Our Case Number: ABP-317660-23

Re: Bus Connects Kimmage to City Centre core bus corridor scheme

Bus Connects Dublin - Kimmage to City Centre Core Bus Corridor Scheme LA Road Development - Application

Bord Pleanála Case reference: HA29N.317660

Programme Title BUSCONNECTS DUBLIN CORE BUS CORRIDORS INFRASTRUCTURE WORKS				
Drawing Title			. 20-30-	
KIMMAGE TO CITY CENTRE CORE BUS PAVEMENT TREATMENT		HEME		
Drawing File Name BCIDD-ROT-PAV PV-0011_XX 00-DR-CR-0004	Sheet Number 04 of 14	Status A	Rev M01

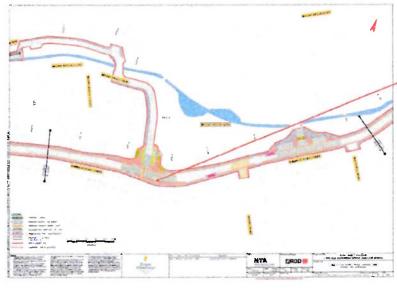
The introduction of raised pavements along this section of Lower Kimmage Road appears to be random and sporadic and there is no discernible reason as to why they are placed at these specific positions. Their presence does however lead to problems and any notional benefits are outwelghed by those problems.

The introduction of **raised pavements** along this section of Lower Kimmage Road appears to be random and sporadic and there is no discernible reason as to why they are placed at these positions. **Their presence does** however lead to problems and any notional benefits are outweighed by those problems:

- The gap between these proposed two (raised) pavements is too narrow to allow for unencumbered access
 and egress to and from the lane which is used for vehicular rear access for up to c 28 properties*, with that
 lane being the ONLY FRONT and PRIMARY vehicular (and home occupants) access for properties 1280 and
 128E Kimmage Road Lower. This obstruction means that vehicles will not have enough room to turn into
 and out of the lane and it will lead to those vehicles having driving into oncoming traffic.
- It will create difficulties for Waste removal companies servicing properties numbered from 128 to 136
 Kimmage Road Lower and will result in emptied bins being further strewn along the road. This practice (of
 not placing bins immediately outside of owning property) WILL be exasperated, leading to pedestrian and
 possibly cyclists movement obstruction.

Cars for properties 128, 128D and 128E are legitimately parked here.

Design amendment required: the proposed raised pavements in front of numbers 126 to 136 Kimmage Road

Lower should be removed. Should any alternative structures be proposed, then they too MUST NOT give rise to
the above identified problems.

Programme Title BUSCONNECTS D CORE BUS CORRIDORS INFRAS		E WORK	s
Drawing Title			
KIMMAGE TO CITY CENTRE CORE BUS TRAFFIC SIGNS & ROAD N		HEME	
Drawing File Name BCIDD-ROT-TSM_GA-0011_XX_00-DR-CR-0004	Sheet Number 04 of 14	Status	Rev MO1

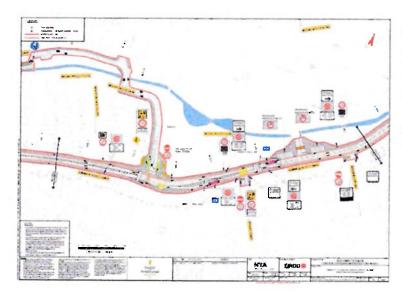
Road markings – provision for and maintenance of lane vehicular access: This scheme drawing appears to suggest that allowance has been made for vehicular access and egress of the indicated lane – should the scheme be approved, this MUST be retained; if the Road markings do not currently cater for that <u>unencumbered</u> access and egress then it SHOULD do so.

Road markings – provision for and maintenance of lane vehicular access; This scheme drawing appears to suggest that allowance has been made for vehicular access and egress of the indicated lane – should the scheme be approved, this MUST be retained; if the Road markings do not currently cater for that <u>unencumbered</u> access and egress then it SHOULD do so.

Note: This lane is used for vehicular rear access for up to c.28 properties*, with that lane being the ONLY FRONT and PRIMARY vehicular (and home occupants) access for properties 128D and 128E Kimmage Road Lower.

Cars for properties 128, 128D and 128E are legitimately parked here.
